WILLISTON CONSERVATION COMMISSION
November 18, 2024

Review Stage: Discretionary Permit

APPLICATION NO: DP 24-09

PROJECT NAME: Benedetto Subdivision

Bottom Left: Discretionary Permit site plan with (3) building lots (shaded red) and (3) open space lots (shaded green).

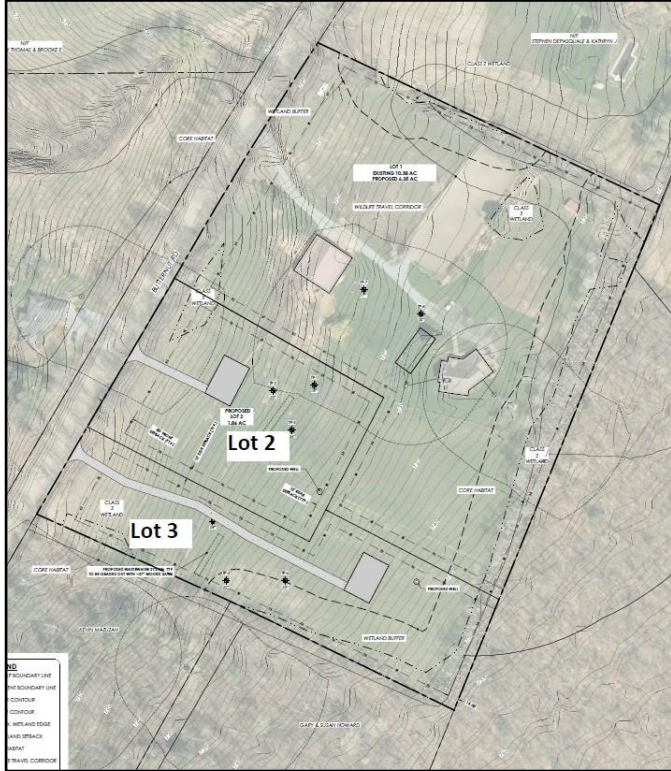
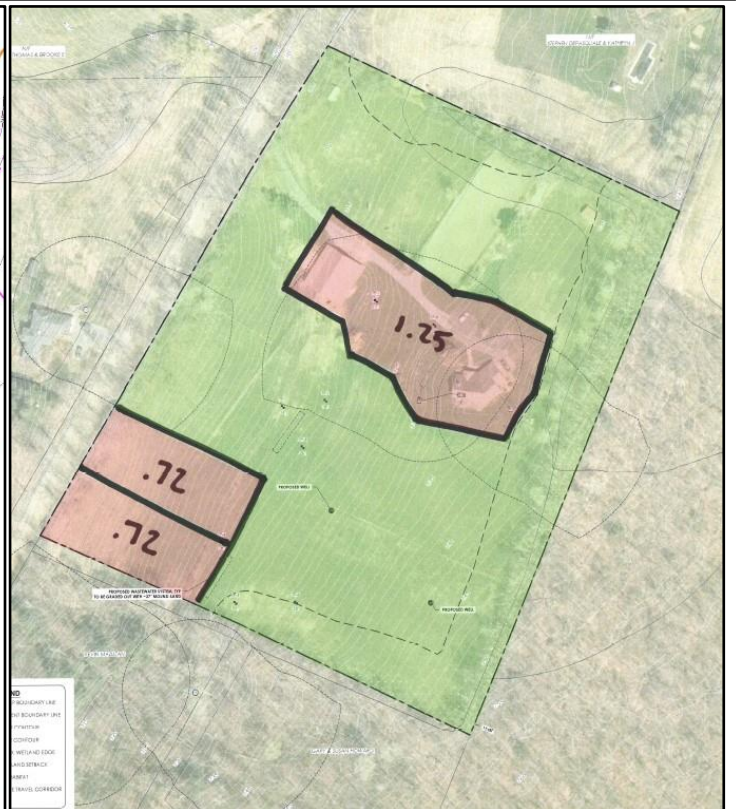
The proposed site plan identifies three (3) "building lots" that are 'floating' within three (3) open space lots. This is the first time the WCC/DRB has reviewed an application for an open space subdivision that proposes open space as separately ownable lots for each building lot.

The WCC should discuss if the proposed site plans meet the requirements of WDB 31.7 and 31.8 and specifically, if the proposed open space is contiguous, then edit Finding #4 accordingly. They should then decide if they would like to provide an additional recommendation to the DRB.

WDB 31.7.3 states that open space must be contiguous within a subdivision and with surrounding parcels, except where doing so is not feasible due to small isolated areas of watershed buffer or site constraints. WDB 31.7.4 states "contiguous open space is generally defined as an area of forest and/or other natural community that is unfragmented by development and remains in a natural state. In establishing standards for contiguity, the Conservation Commission and DRB will consider the context of the proposed development, including the type and relative value of resources as identified in WDB 27, 28, and 29 to be protected, and the configuration of open space that will best ensure the protection of those resources."

Most of the subject site is pasture surrounded by wooded area or fields mapped as SWHA on adjacent parcels. The bylaw gives the DRB and WCC discretion in determining the configuration of open space, but WDB 31.7.3 requires that open space be contiguous. The bylaw does not provide further guidance in 31.7 for what "contiguous open space" looks like, especially in areas that are not specifically mapped for habitat protection, wetlands, important farmland, or steep slopes.

WDB 31.7.7 states that protected open space must be platted as a separate lot. The singular language in this requirement suggests that open space will be one (1) lot, but it does not clearly require it. The current plat does not show pin locations for "building lots" or show them with the same symbology as "open space" lots. The plat must show a driveway easement for building lots 2 & 3.

WDB 31.8 states that “housing (or other) development may take place on no more than 25% of any site of more than 10.5 acres.” WDB 31.8.1 further states that specific home sites must be designated on a portion of a proposed open space development that is 25% or less of the developable area. The bylaw does not specify whether the area proposed for development needs to be contiguous or if the “portion” of land used for development can be separated by open space and therefore spread over an area that is greater than 25% of the parcel.

1. Signage delineating watershed protection buffers on a 100' interval as proposed **is/is not** acceptable.
2. Open space must be one parcel and the proposed building lots shall be clustered closer together to reduce fragmentation of the open space.
